# DEVELOPMENT REVIEW COMMITTEE (DRC) COMMENT REPORT

**PROJECT NAME:** Sistrunk Quarters

**CASE NUMBER:** PLN-SITE-19110005

**REQUEST:** Site Plan Level II Review: Renovation of 1,789 Square Foot Existing Retail Building and Construction of a New 2,289 Square Foot Restaurant with Drive-Thru and Parking Reduction in Northwest Regional Activity Center

Graphic example of rear wall and description of materials.

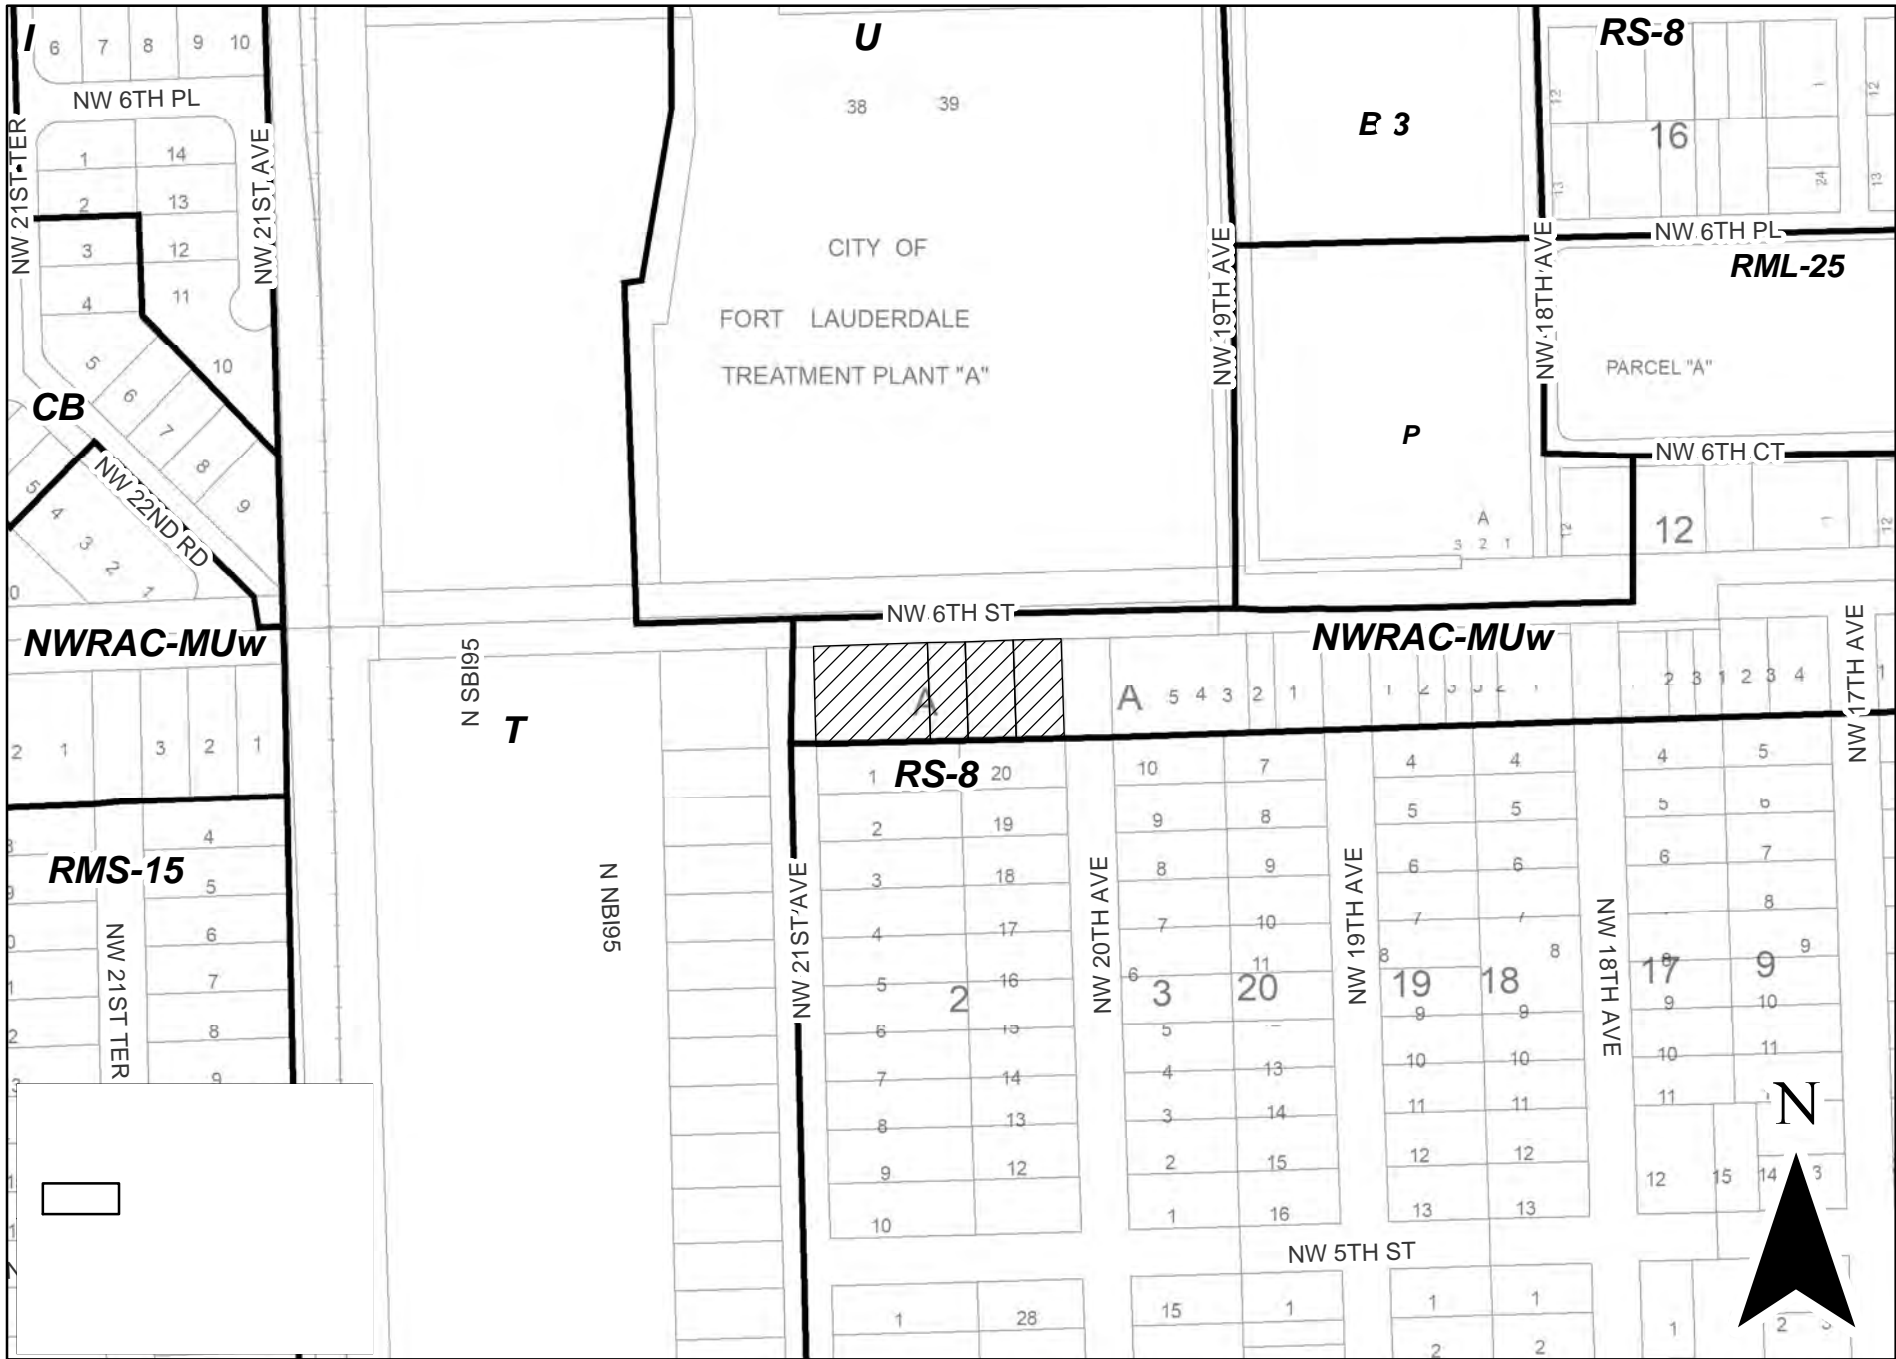
- 7) Provide the following changes on the elevation plans:
  - a. Update elevation drawings with changes to dimensions on site plan.
  - b. Identify material on building exteriors and provide graphic examples of each material.

- c. Provide additional renderings and specifications on the architectural banner crossing driveway entrance- height, material, etc. Provide clearance dimensions on plans.

- d. Clarify if both building facades are being modified. If so, update elevation plans to show building elevation height and materials accordingly.
- 8) Provide roof plan for all structures indicating the location of all mechanical equipment. This plan shall include spot elevations of the parapet wall and roof as well as mechanical equipment to verify adequate screening and to illustrate how equipment will be screened or shielded from view. Roof mounted structures shall be required to be screened with material that matches the material used for the principal structure and shall be at least six (6) inches high above the top most surface of the roof mounted structure. In addition, indicate all mechanical equipment within the subject site on the site plan and elevations where applicable. Discuss the use of the roof as an accessible amenity. Height is measured to the slab for flat roofs and use of the roof by residents or customers is limited based on this

maximum height. Please describe in detail the proposed use of the roof and if access is intended now or in the future.
